# Interaction of Electromagnetic Pulse with Commercial Nuclear Power Plant Systems

Main Report

NUREG/CR-3069, Vol. 2  
SAND82-2738/2  
AN, 1S, 9E, 9U

This study examines the interaction of the electromagnetic pulse from a high altitude nuclear burst with commercial nuclear power plant systems. The potential vulnerability of systems required for safe shutdown of a specific nuclear power plant are explored. EMP signal coupling, induced plant response and component damage thresholds are established using techniques developed over several decades under Defense Nuclear Agency sponsorship. A limited test program was conducted to verify the coupling analysis technique as applied to a nuclear power plant. The results are extended, insofar as possible to other nuclear plants. Based upon the analysis, it was concluded that: (1) Diffuse fields inside Seismic Class I buildings are negligible; (2) EMP signal entry points are identifiable; (3) Interior signal attenuation can be reasonably modeled; (4) Damage thresholds, even for equipment containing solid state components are high; (5) EMP induced signals at the critical equipment in the example plant are much less than nominal operating leve

Figure 4.2. Simplified One-Line Diagram Watts Bar Nuclear Plant Electrical Power System.

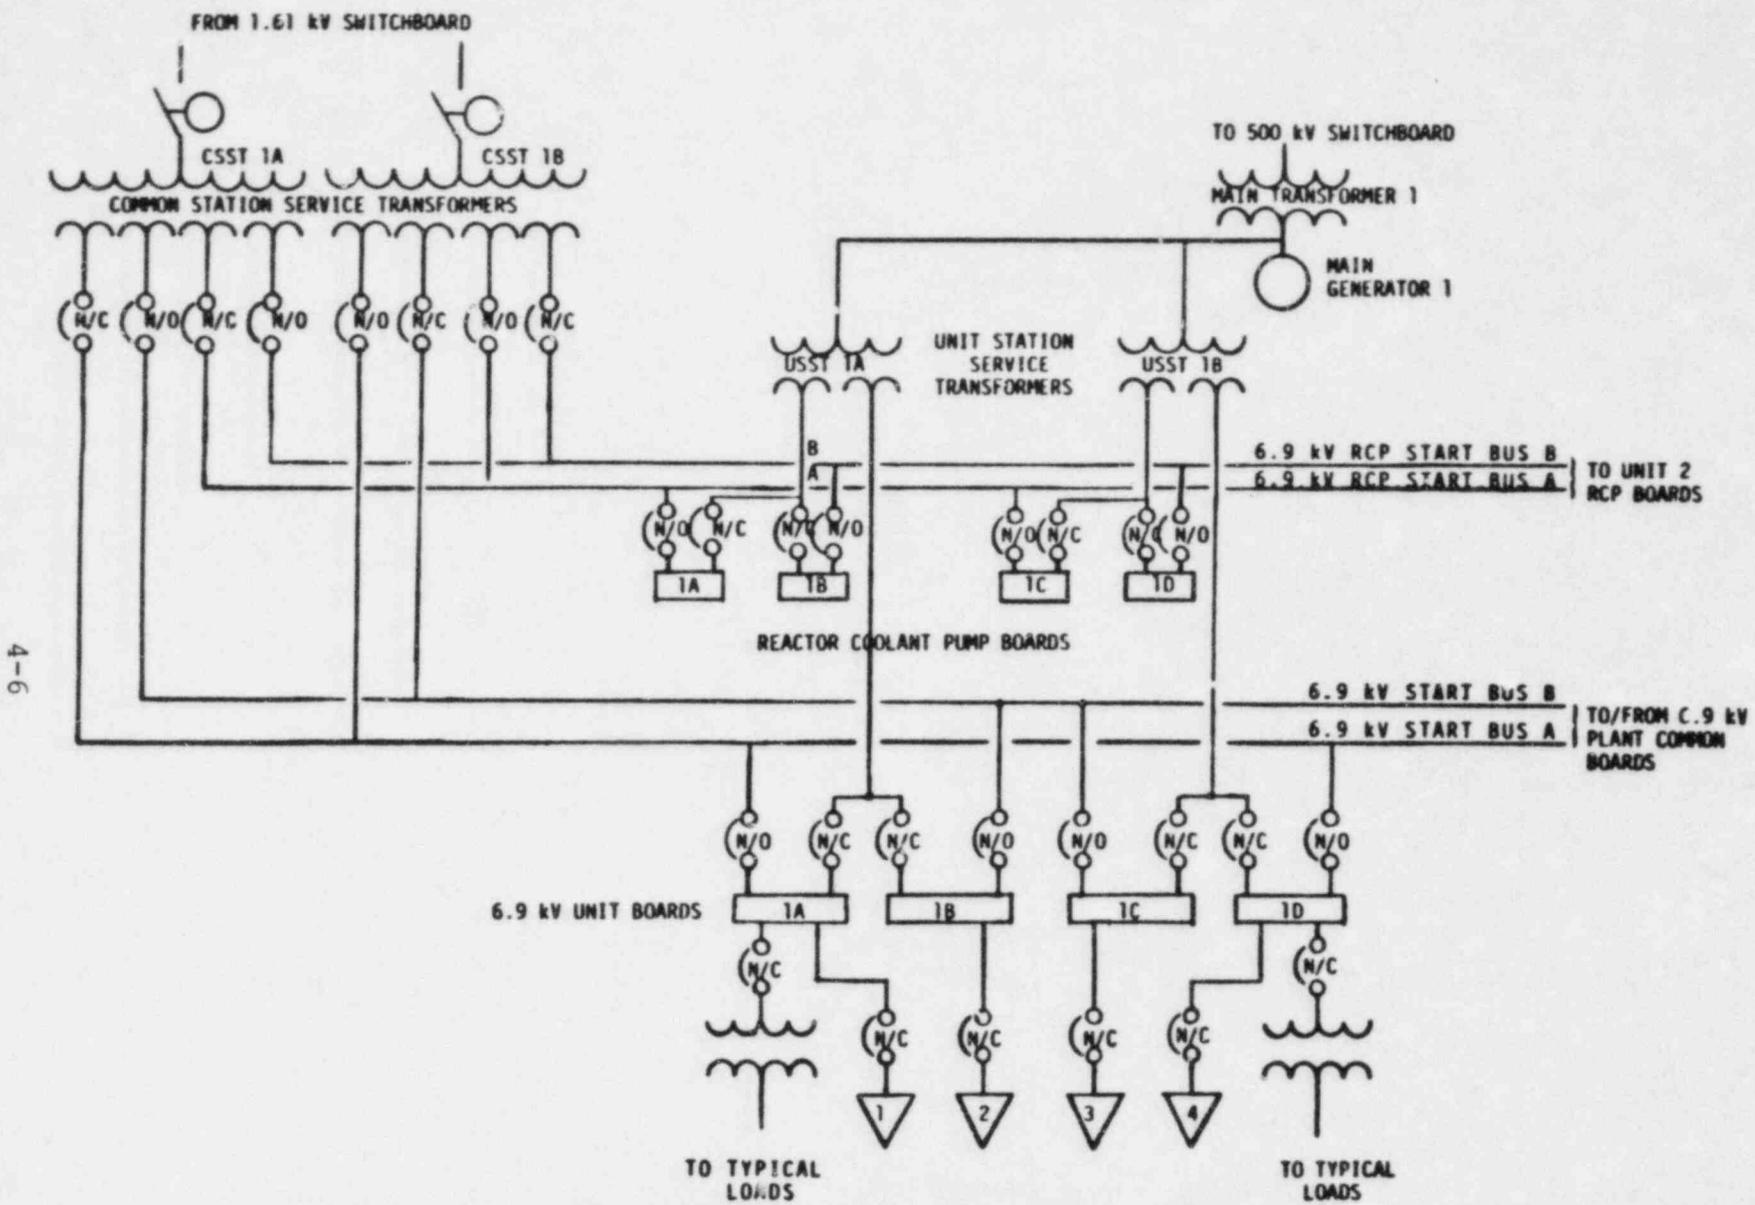
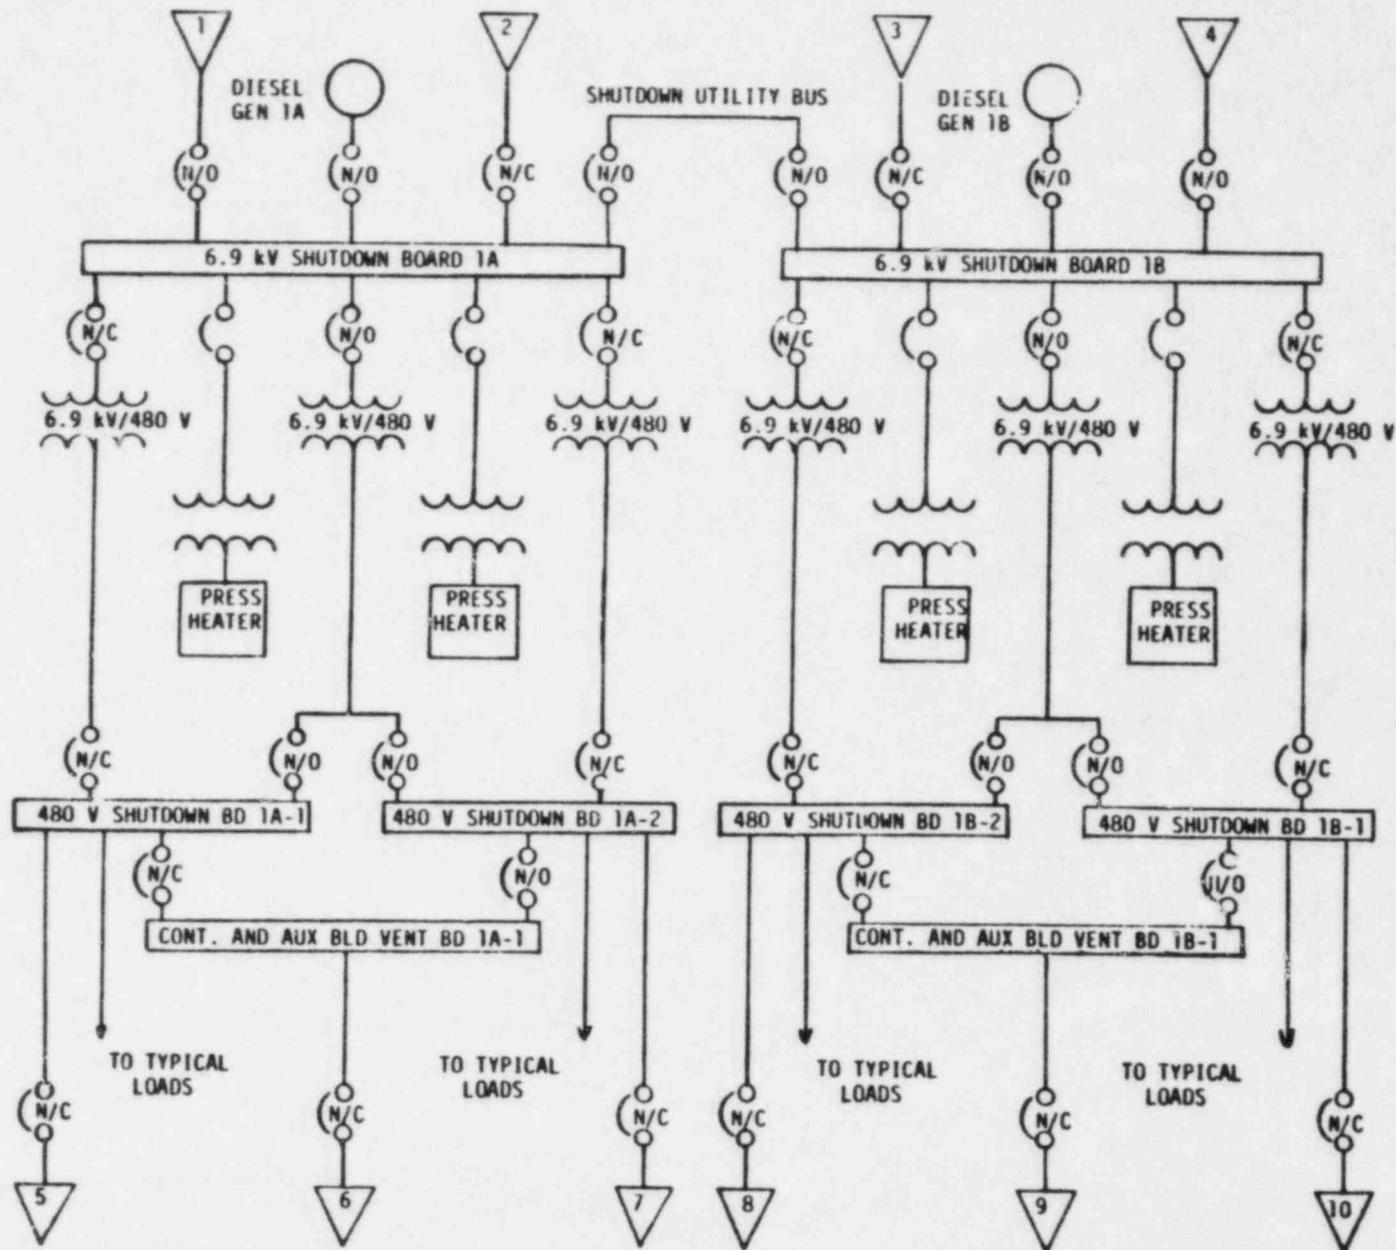
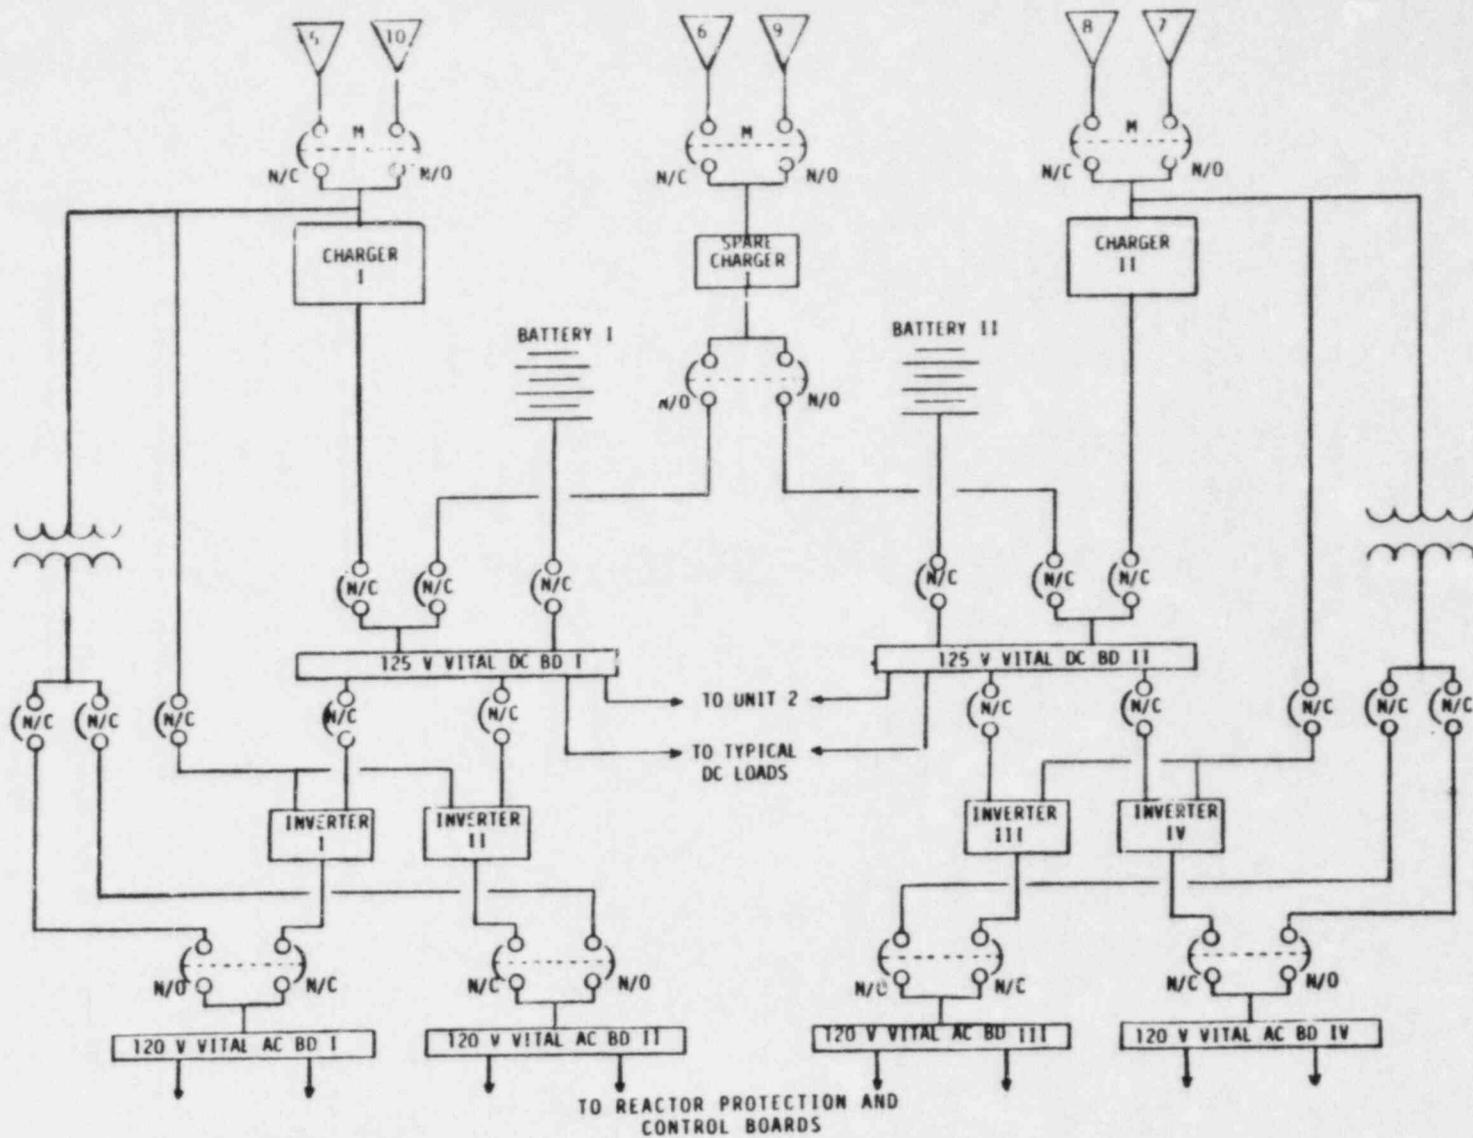
9. Section 5.2 (Pg. 39): It is noted from Figure 4.2 that there is one less transformer in series between the transmission grid and the shutdown buses when they are connected to the 161 KV system than when they are connected to the 500 KV system. Therefore, there is 10 dB less attenuation of the threat pulse originating on the transmission grid. A paragraph should be added to Section 5.2 to explicitly address this point and its effect on the results of the analysis, which was performed assuming the buses were connected to the 500 KV system. The percentage of the time the 161 KV connection is expected to be in effect should also be stated.

5. In Figure 4.2 (page 31), the 6.9 kV N/O secondary circuit breaker of CSST1A transformer feeding 6.9 kV, RCP start, Bus "A" should be shown as N/C.

Figure 5.1. Response Model Diagram for Intake Structure.

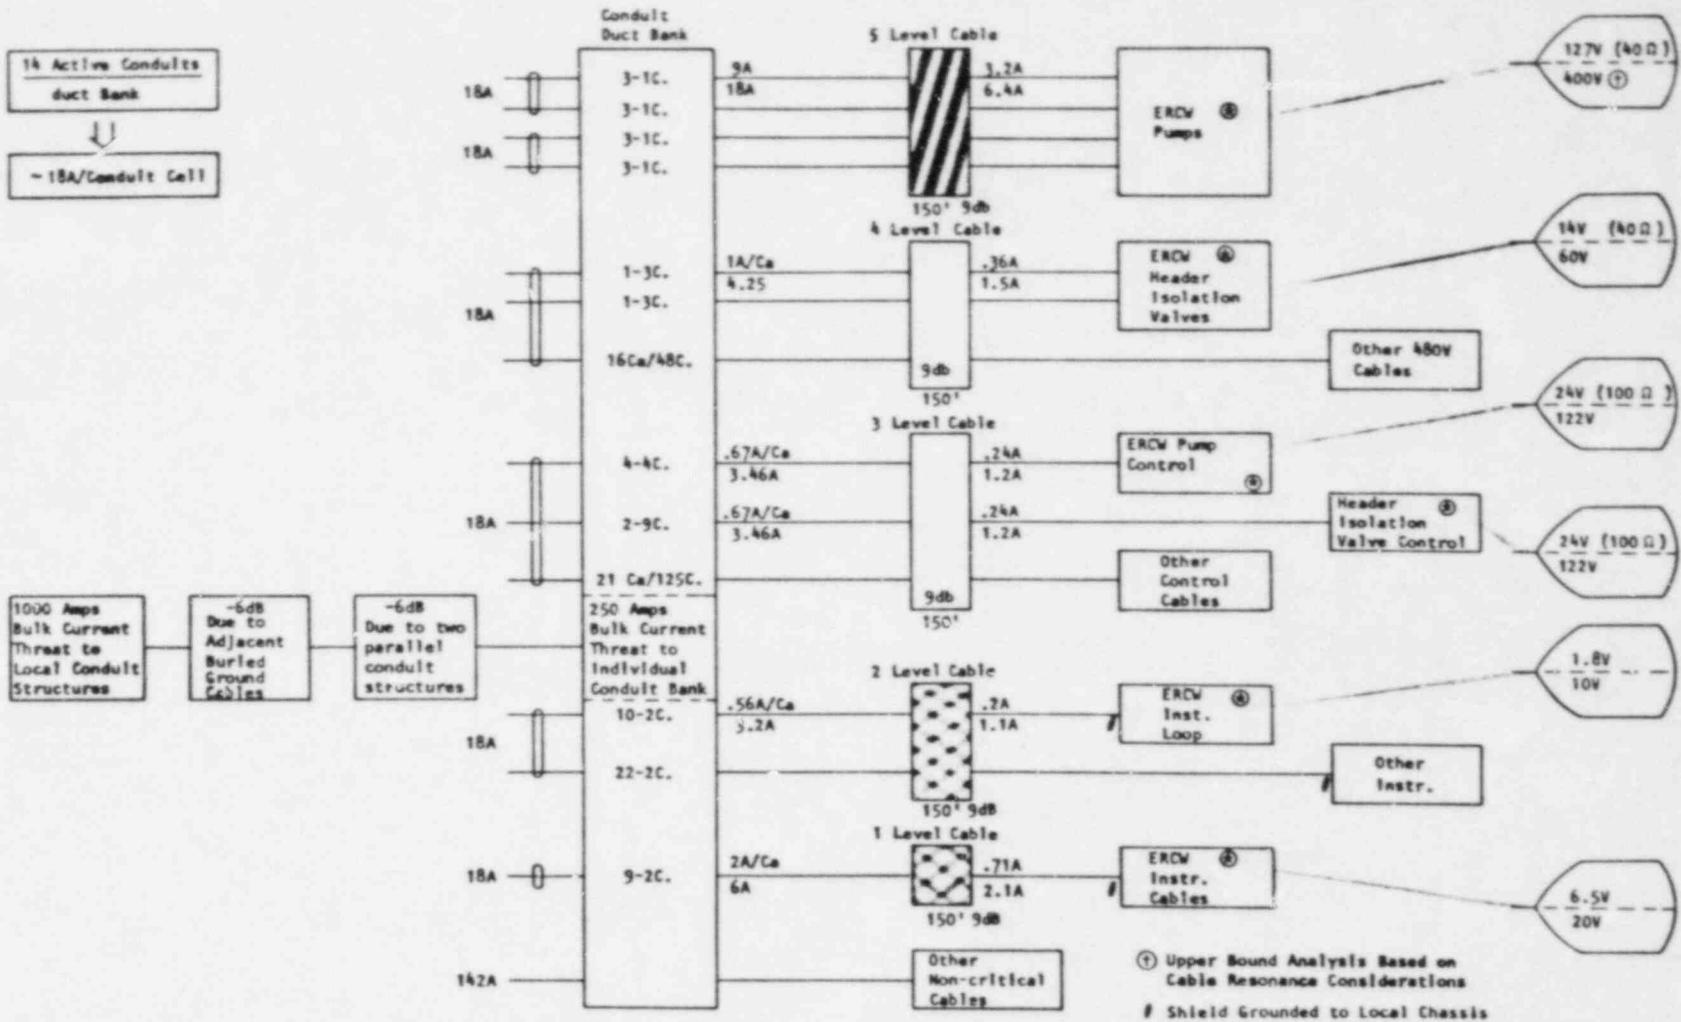
10. Section 5.2 and Appendix A (Pg. 38, 39, Figs. 5.1 and A-2): The first paragraph on Pg. 38 states that the peak bulk current threat is bounded between 1000 and 2000 amps. However, Figure 5.1 indicates a peak bulk current threat of 1000 amps. It is assumed that this value was used in the analysis. What is the basis for selecting 1000 amps? It is noted that in Fig. A-2 for the similar situation of the 500 KV transmission lines the bulk current threat is 15K amps and this value is the geometric mean of the bounding values of 10K to 20K amps given on Pg. 39. Section 5.2, Appendix A and the figures cited should be revised to clarify this point and for consistency.

Figure 6.23. Ratios of Interior and Exterior Electric and Magnetic Fields vs Frequency, Antenna Position B, Test Point A

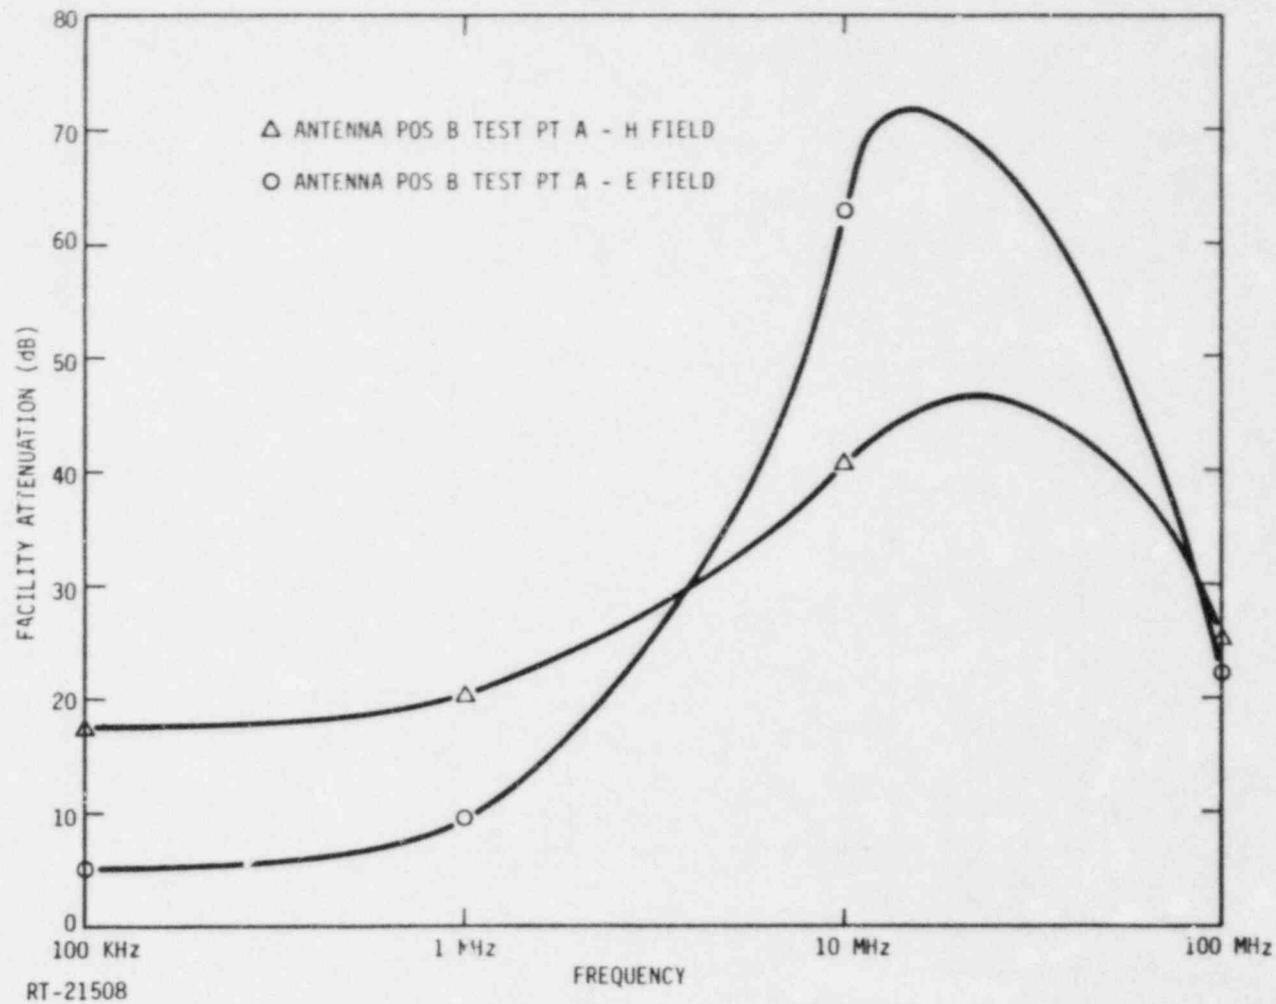
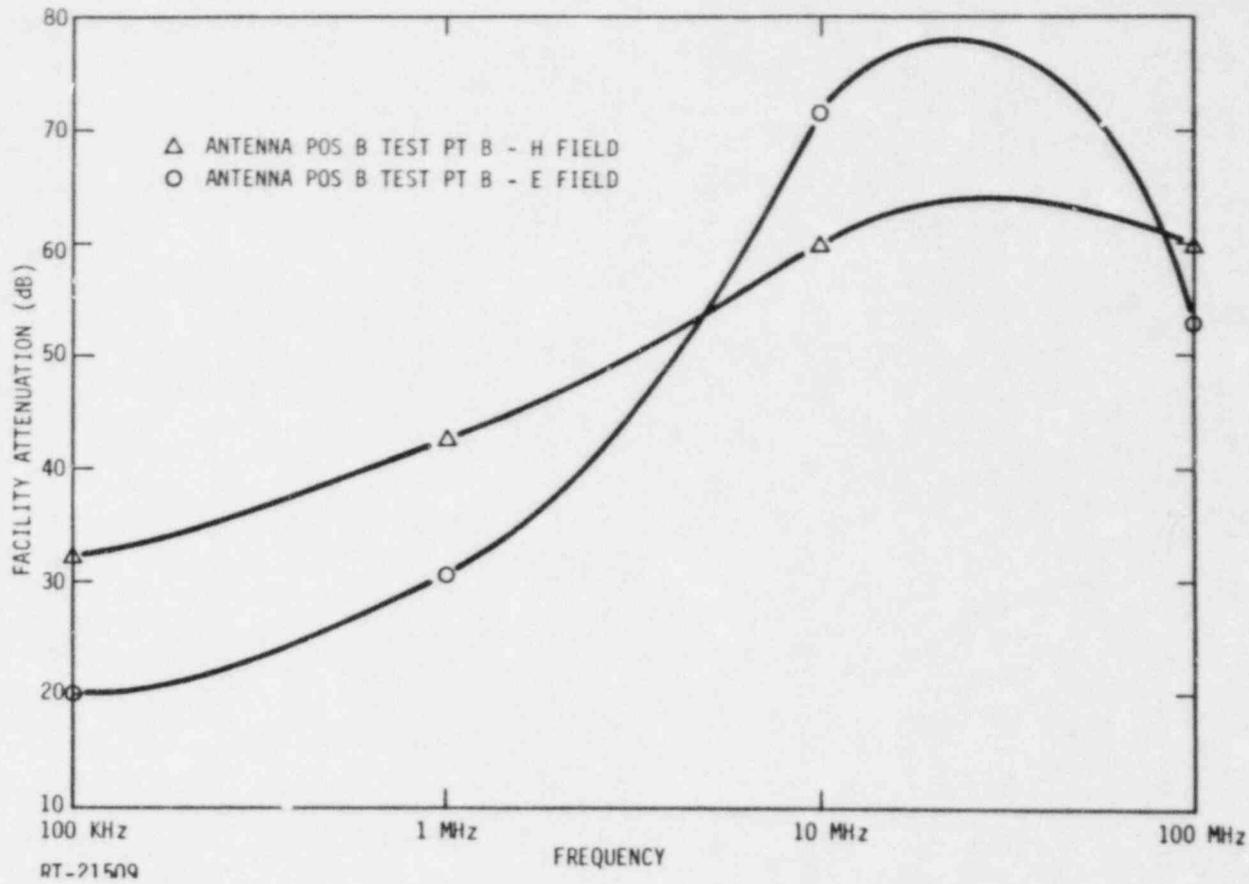
- f. In paragraph (L) the reviewer indicates that shielding effectiveness test values were as low as 10 dB at 1 MHz. Again there appears to be some misunderstanding. Figures 6.21, 6.23 and 6.24\* show attenuation, not plane wave shielding effectiveness, of a transmitted signal as a function of frequency. In Section 6.5.3 arguments are presented relative to deducing some bounds on the plan wave SE from these attenuation measurements. Some revisions to the text have been made and we believe that they will clarify this point.

d. In Section 6 I can't follow the reasoning leading to 32dB shielding effectiveness for the plant enclosure. Looks as if 17dB is the logical choice from Figure 6.23.

3. It is agreed that the curves illustrated in Figures 6.23 and 6.24\* have been constructed with only a few points. However, these were extracted from a complete set of swept CW response measurements over the frequency band 10 kHz to 100 MHz. Assessment of these functions does not indicate any significant discontinuity. (See Appendix 5, Reference 13). Some additional information has been provided in Section 6, which should clarify the basis for the curve shape reported. Essentially, all that is shown here is the attenuation, not shielding effectiveness, for the fields associated with the monopole (not plane wave). An attempt to deduce plane wave shielding effectiveness is developed in Section 6.5.3. Qualifications on the conclusions are also stated.
